SOME THOUGHTS ON EXPERIMENTAL AREAS

J. R. Sanford

August 28, 1967

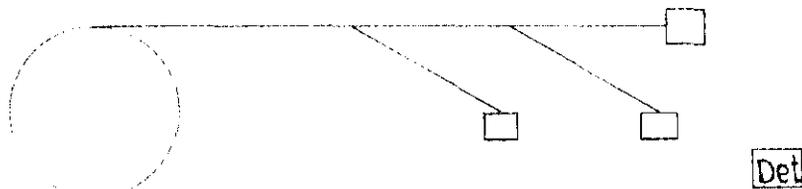
2. Don't get the experimental halls in the EPB too close together. Closeness made some sense to me earlier when the buildings were oriented

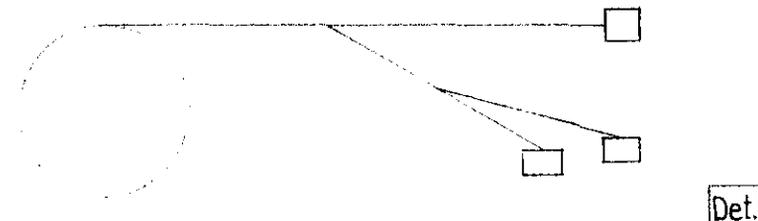
3. Put them at different longitudinal distances from the detector area. In this regard you are probably further along if you build them as

Both this and the following should be cost estimated.
